# UNITED STATES PATENT AND TRADEMARK OFFICE

10/550,717

<b>Office Action Summary</b>	<b>Application No.</b> 10/550,717	<b>Applicant(s)</b> KISMIR, ALTAY	
	<b>Examiner</b> LAURA FREEDMAN	<b>Art Unit</b> 3616

### **DETAILED ACTION**

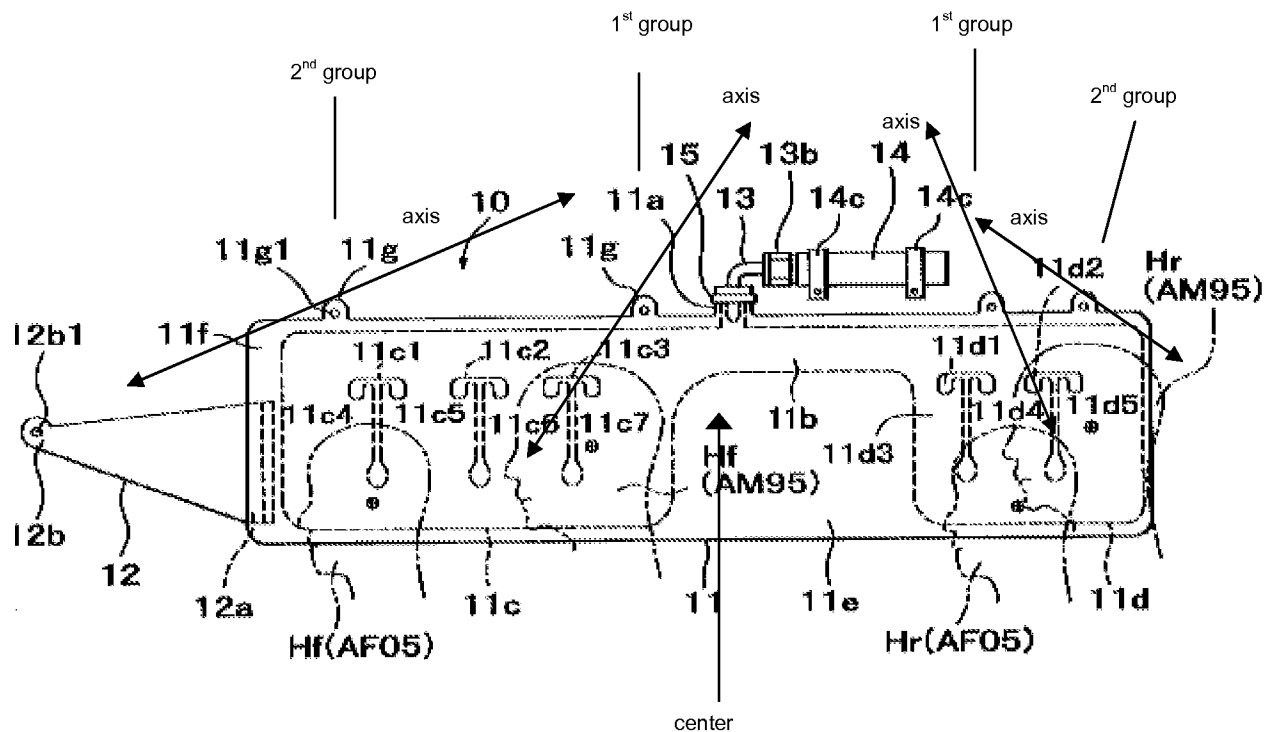
4. Claims 1-7 are rejected under 35 U.S.C. 102(b) as being anticipated by Takahara (US 20020140211). Takahara discloses an airbag (for example, including inflatable curtain #11) comprising:

- Inflatable region (for example, including #11b, 11c, 11d)
- Upper edge (for example, edge along top of airbag that includes mounting tabs)
- Mounting tabs (for example, including #11g)

- Axes (see marked-up version of figure 2 below) inclined inwardly toward a region above the center of the airbag (though drawings are not necessarily drawn to scale, incline angle is between  $30^{\circ}$  and  $80^{\circ}$ )

- First group of tabs (for example, including one tab #11g on either side of gas inlet #11a) positioned near the center (see marked up version of figure 2 below)

- Second group of tabs (for example, including remaining two tabs #11g located further from gas inlet #11a) positioned outwardly from the center and the first group of tabs and inclined with a more acute angle than the first group of tabs (see marked-up version of figure 2 below)

- Mounting tabs formed of a woven fabric (for example, including same woven fabric of airbag) having orthogonal warp and weft yarns (extending in longitudinal and vertical directions; including paragraph 0020), the axes making an acute angle with the orthogonal matrix of the warp and weft yarns (for example, since the axes make an acute angle with the longitudinal and vertical directions, then the axes would also make an acute angle with the orthogonal matrix of the warp and weft yarns)

- Axis of each tab defined by a side edge of the tab (see marked up version of figure 2 below)
- Tabs formed from a single layer of material forming the air bag (for example, tabs formed of same material as airbag)

Examiner notes that while examples of axes of the mounting tabs have been designated in the marked up version of figure 2 below, various other axes could be pointed out

along side edged of the tabs and would also read on the claims above in a similar manner.
